RE: Preliminary Plan No. 120190150  
Takoma Junction  
**AMENDED LETTER**

RE: Preliminary Plan No. 120190150  
Takoma Junction  
**REVISED LETTER**

RE: Takoma Junction  
Traffic Impact Study Review

Subj: Stormwater Management Concept SWC-18-05-07  
Takoma Junction  
7225 Carroll Avenue

**MD 195 (Carroll Avenue) at Site Driveway**

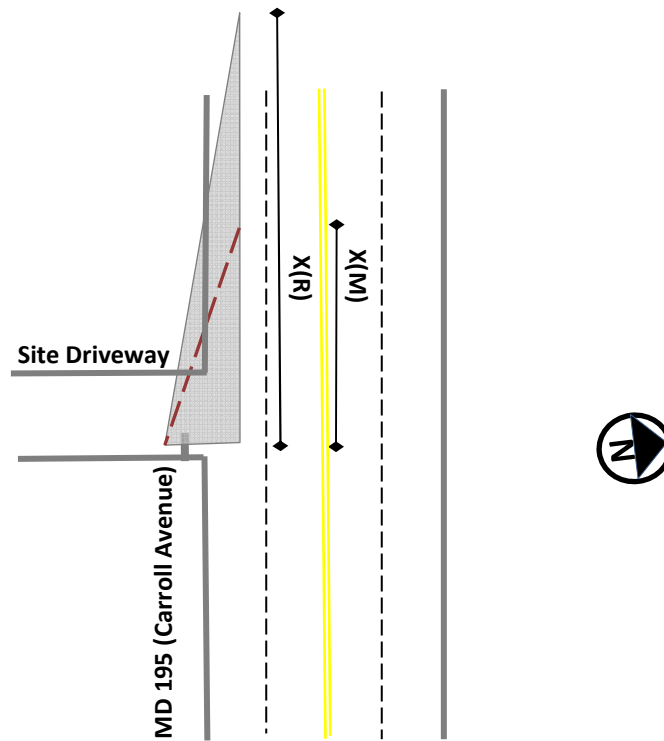
An internal evaluation of the stopping sight distance at the proposed driveway was performed. The results of our analysis are attached. The results show that both intersection and stopping sight distance will not be met at the driveway. Your proposed mitigation may be a deciding factor in our determination of future action on this development.

Figure 2. Stopping Sight Distance Notes

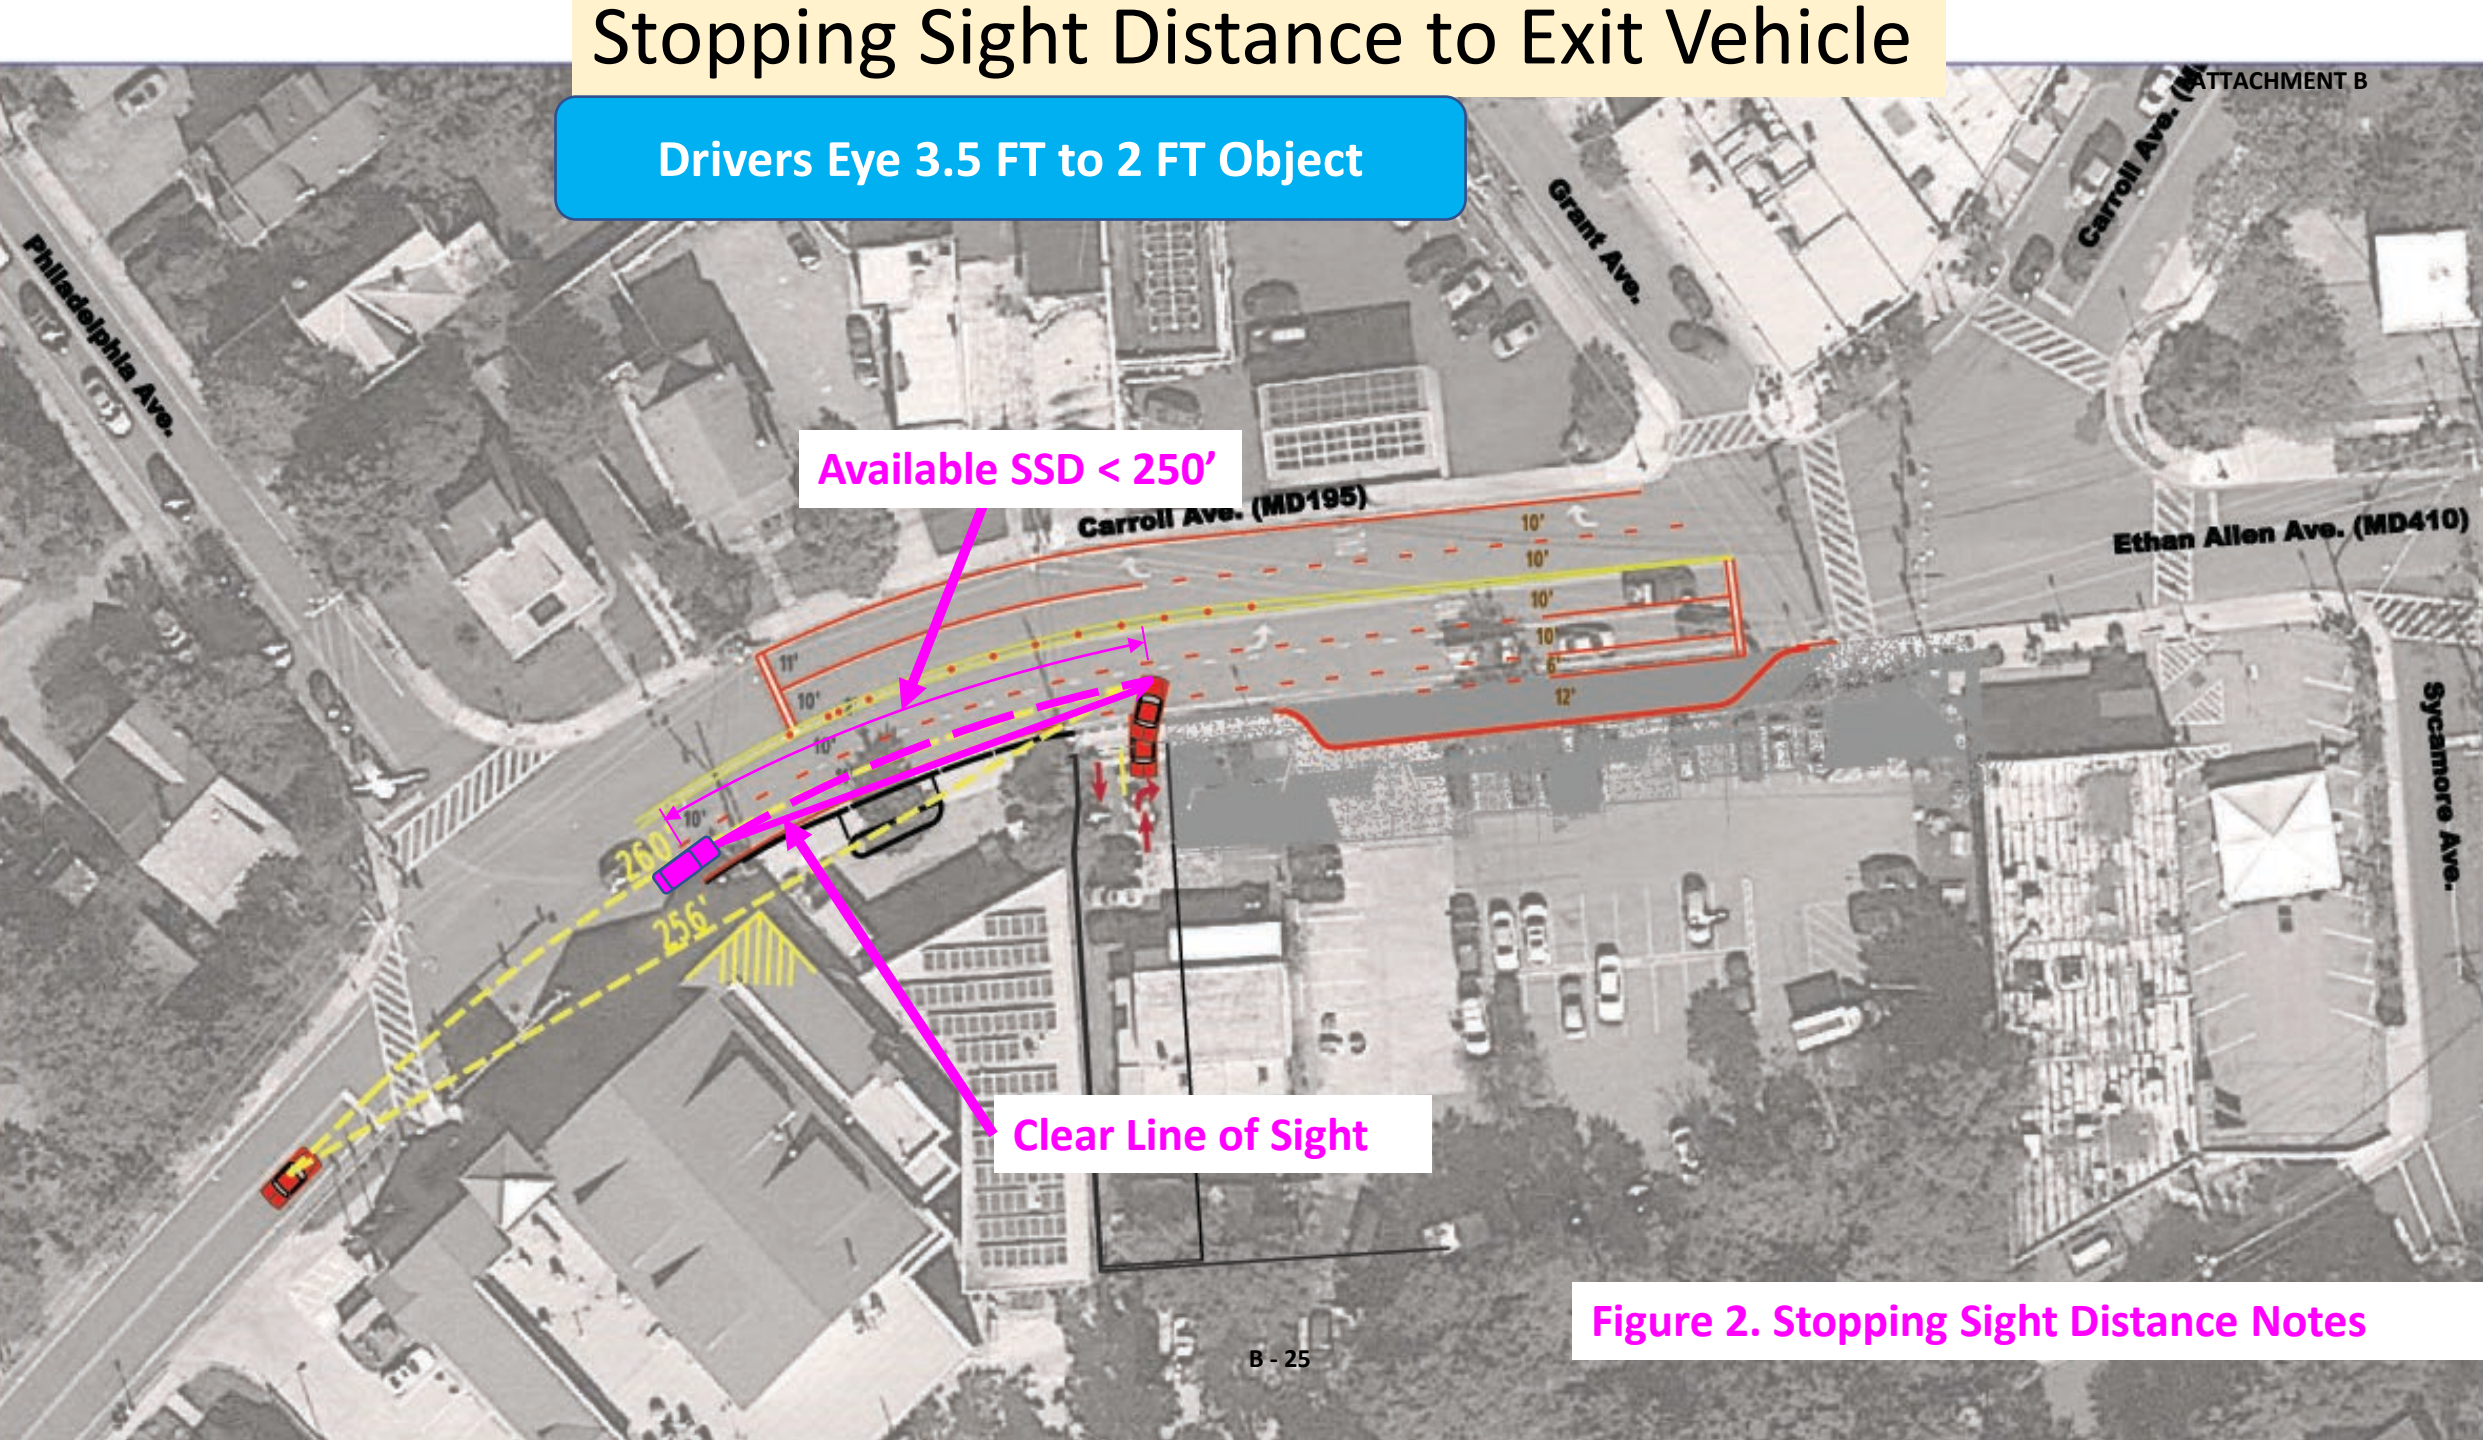
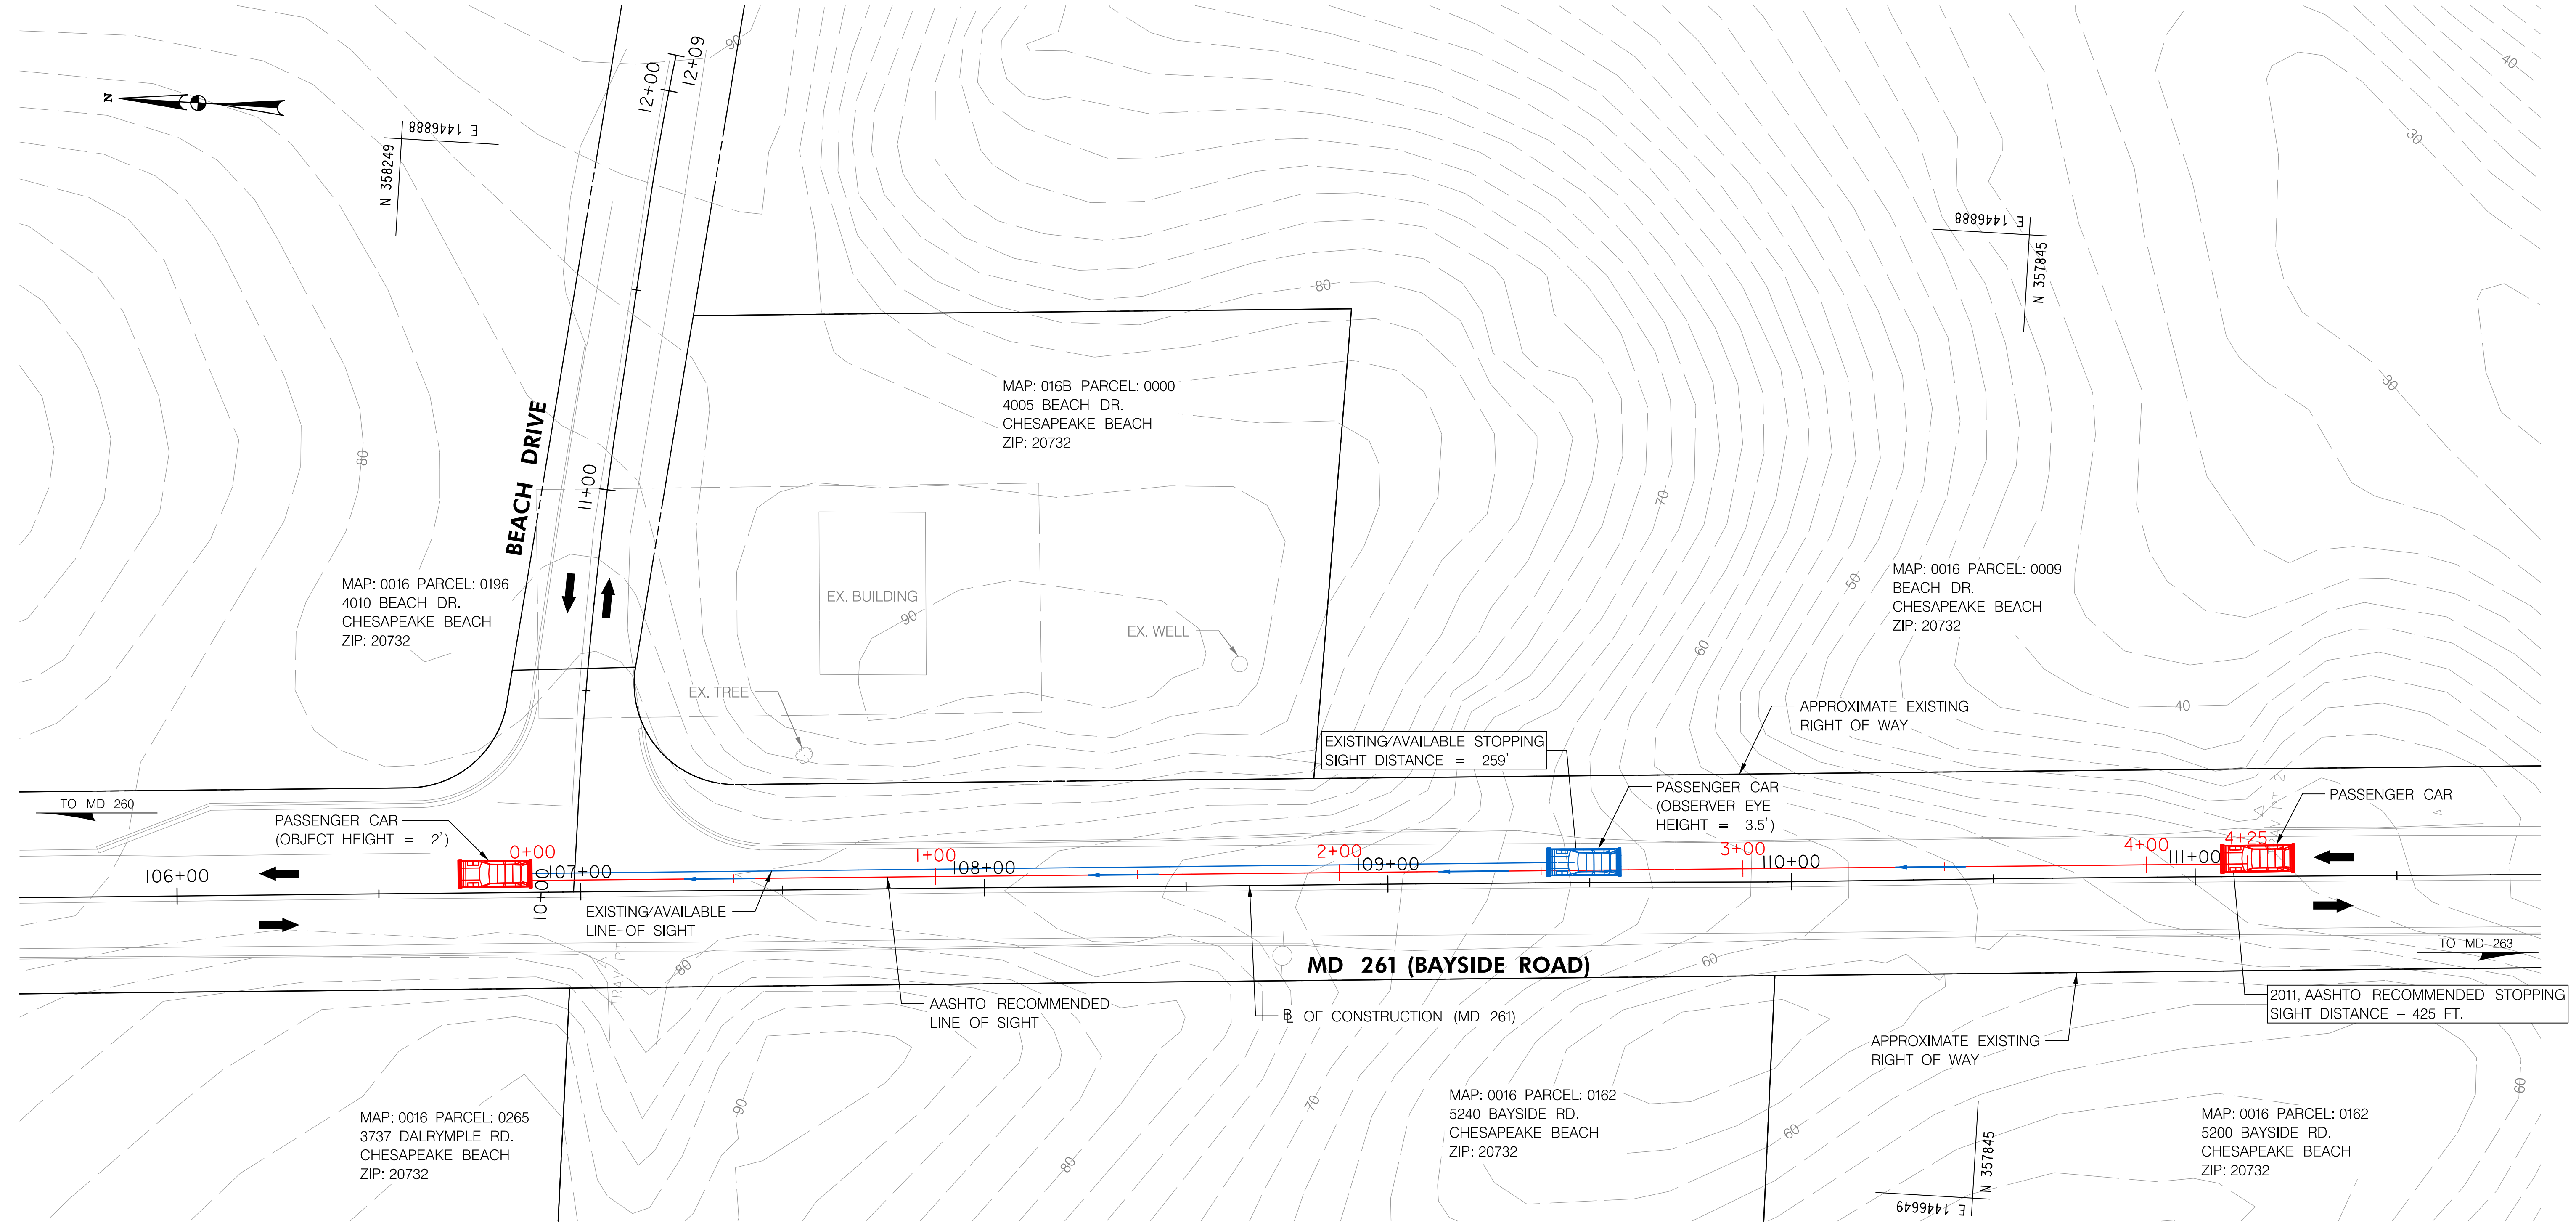
Figure 1. Sight Line Obstructions

Available SSD < 250'

Figure 9-17. Departure Sight Triangles for Intersections

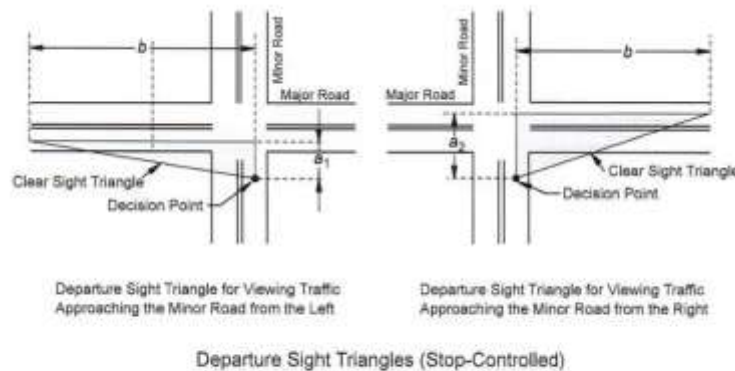
- The sight distance measurements were not conducted in accordance with professional standards of practice as specified by the American Association of State and Highway Transportation Officials (AASHTO). Please refer to the AASHTO Green Book for the appropriate methodology. The Institute of Transportation Engineers Manual of Transportation Engineering Studies and the Traffic Engineering Handbook provide additional guidance. Sight distance identified as dimension  $b$  below (for intersection sight distance), is measured as part of an intersection sight triangle with a decision point located 14.5 feet from the edge of the major road traveled way. Figure 9-17 from the AASHTO Green Book copied below illustrates.
  - Sightlines are measured along a straight line
  - Sightlines do not curve with the vehicle path
  - Sightlines do not curve around objects

Related object heights are as indicated in the Manual. Please revise accordingly.
